Subject: Collin County Healthcare Facility, Parking Garage, and Medical Examiners
Revised Request for Change (PCO) No. 017; RFI #87 HC Gutter Detail HC-A7.52/1

Issue No. 017 - RFI #87 HC-Gutter Detail HC-A7.52/I

RFI #87: HC - Gutter Detail HC-A7.52/1

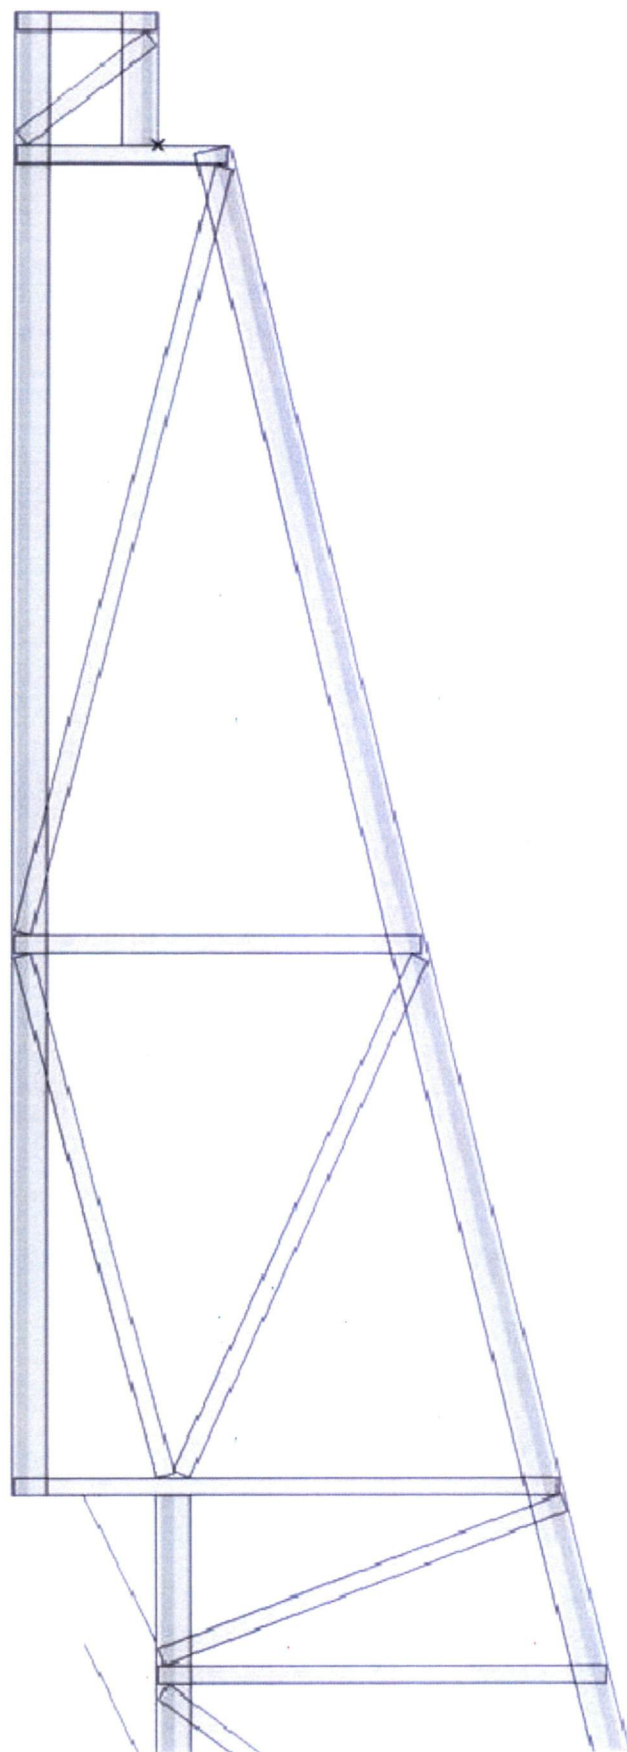
Please review the attached. Per Engineer comments, this detail isn't going to work without some structural steel for support. It eludes to being supported from the trusses but the trusses are designed at 6' OC. Please provide additional details to support the gutter.

If the directive is to reduce spacing of these trusses to help support the gutter there will be additional costs involved. Also, we aren't even sure that reducing the trusses spacing would be enough to support the gutter. Please advise.

Please see Structural Engineer's response.

See WPM response attached.
